Fairfield Village, Fairfield

Darebin Amendment C161

Expert Urban Design Evidence

Instructed by
City of Darebin

Figure 8: Front setbacks with retained single storey building in Area 1
(source: exhibited DDO21)

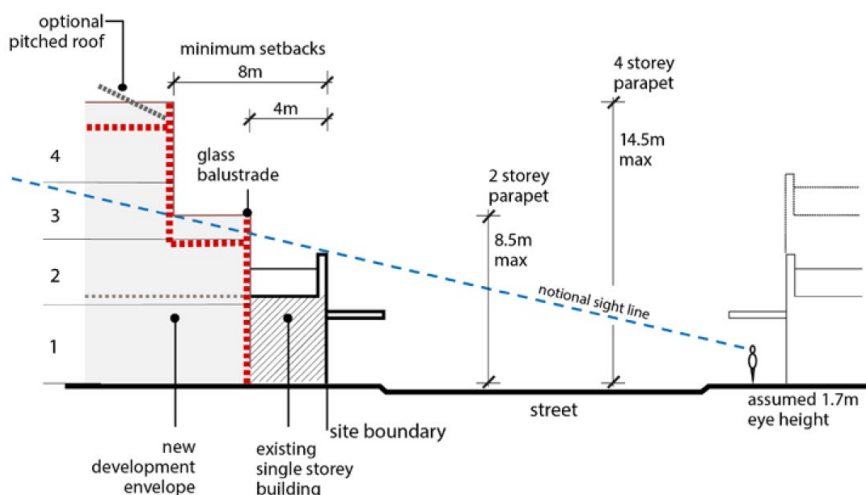
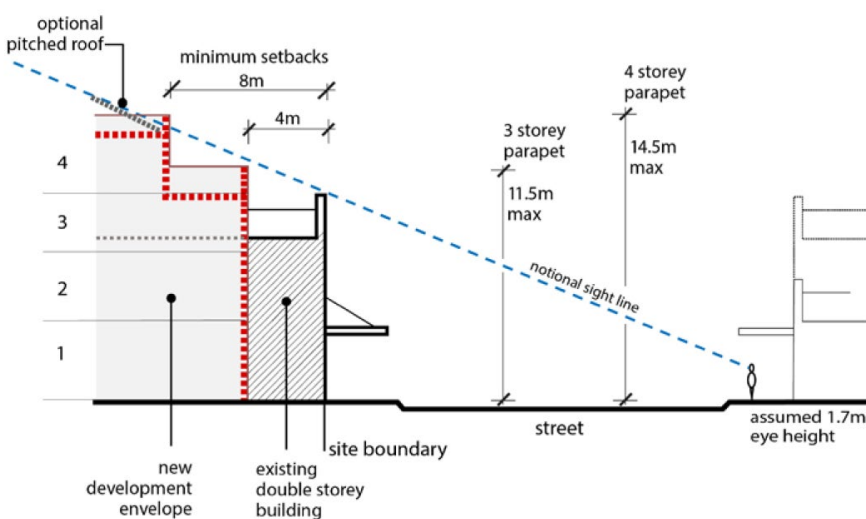
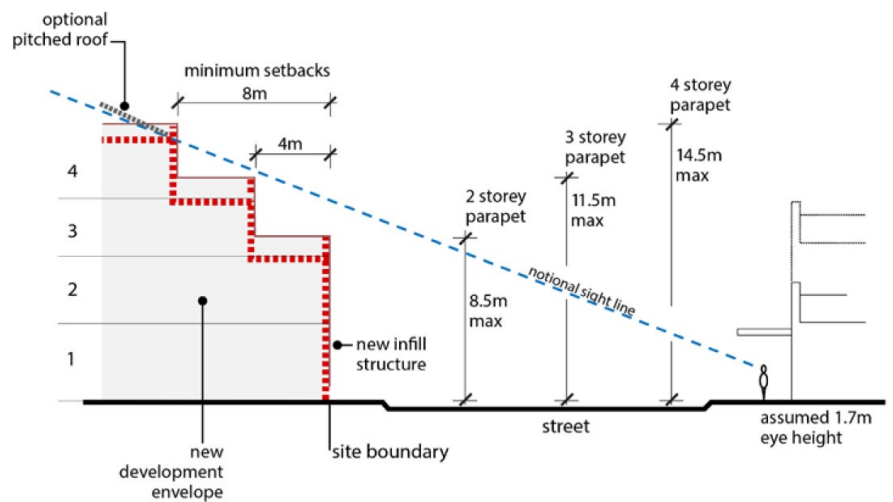
- Limit overly prominent new buildings as seen from oblique views in the street.
- [58] In relation to the proposed upper level setbacks, I support the discretionary nature of the control and the intent. However, I have the following concerns:

- The different minimum setbacks per floor creates unnecessary stepping and a complicated overall building composition;
 - The upper setback requirement of 8m is unnecessarily large considering the depth of heritage retention required (4m) and the modest overall building height; and

- The upper levels will be visible in oblique views with or without the stepping. A simpler upper form will be more useful in reducing prominence when viewed on the oblique. The prominence of the

upper form will also be reduced through the introduction of side setbacks to the top level, creating sky views between built form.

[59] Based on the above, I recommend the following revised upper level setbacks. The diagrams at Figures 11 – 13 include sight lines which helped to determine the extent of the upper level setback required to ensure that the view of the building from the opposite footpath occupied by the upper form was appropriately limited and subservient to the street wall. Further to this, the upper level setbacks proposed will also simplify the form as viewed obliquely. I note that site by site heritage considerations may lead to a different setback.

Figure 11: Proposed front setbacks with retained single storey in Area 1

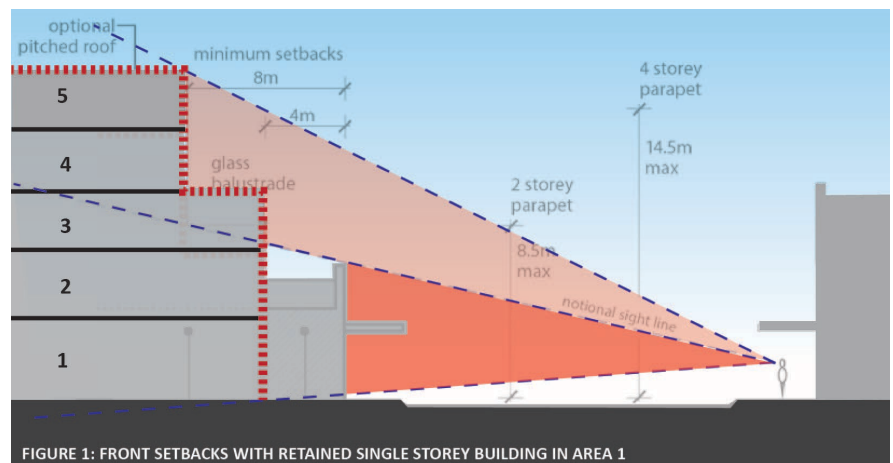
- For a single storey building to be retained in Area 1 introduce the following setbacks from the street wall:

→ Setback 4m up to the 3rd storey; and

→ Setback 8m up to the 5th storey.

Figure 12: Proposed front setbacks with retained double storey building in Area 1

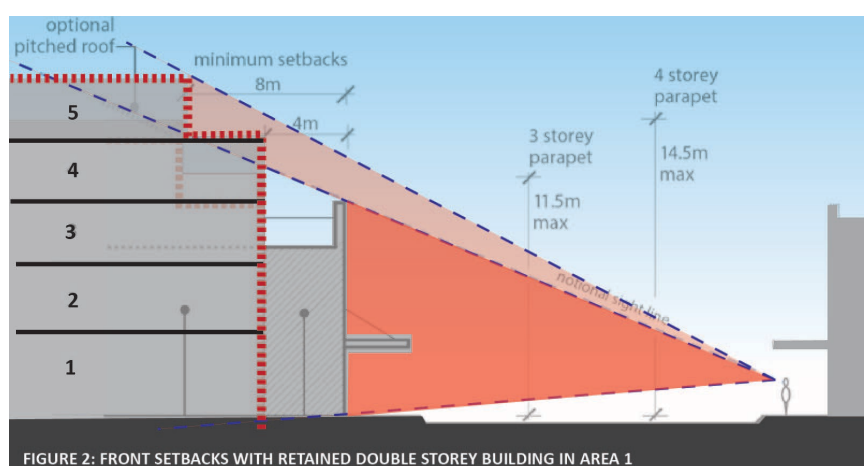
[60] For a double storey building to be retained in Area 1 introduce the following setbacks from the street wall:

→ Setback 4m up to the 4th storey; and

→ Setback 8m at the 5th storey.

Figure 13: Proposed front setbacks for new building in Area 1

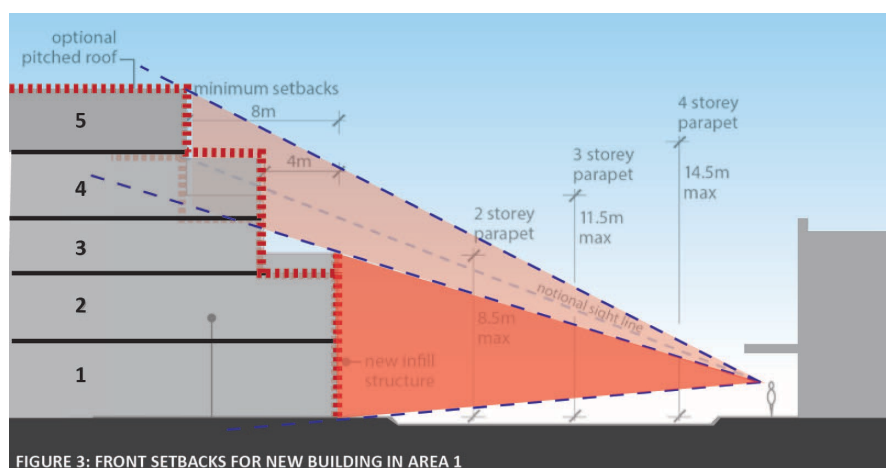
[61] For a new building with an 8.5m street wall in Area 1 introduce the following setbacks from the street wall:

- Setback 4m up to the 4th storey; and
- Setback 8m at the 5th storey.

Figure 14: Front setbacks with retained in Area 2 (source: Exhibited DDO21)

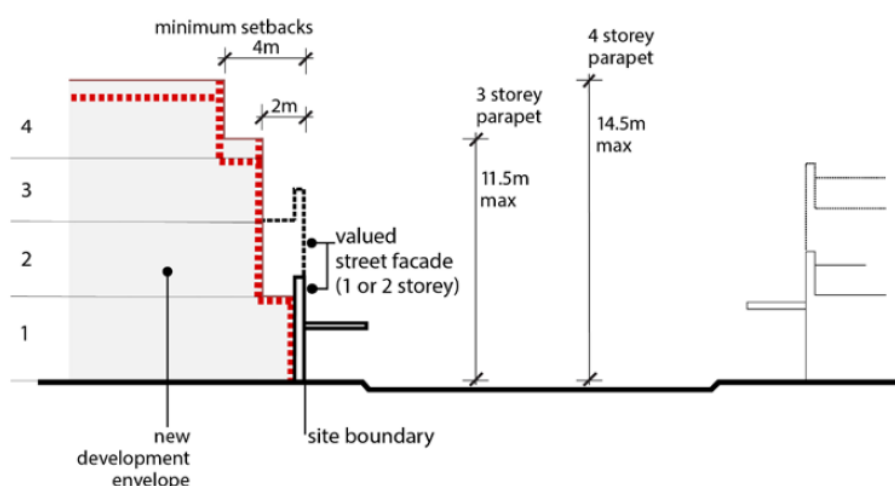
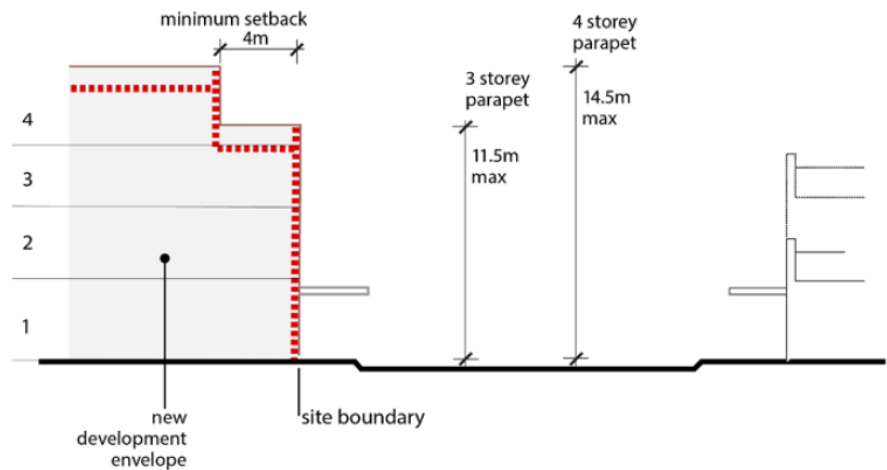
- [65] Similarly to Area 1, I support the discretionary nature of the control but recommend the unnecessary stepping is simplified.
- [66] Based on the above, I recommend a 4m upper level setback for the 2nd, 3rd and 4th storeys and an 8m setback for the 5th storey of buildings to be retained in Area 2.
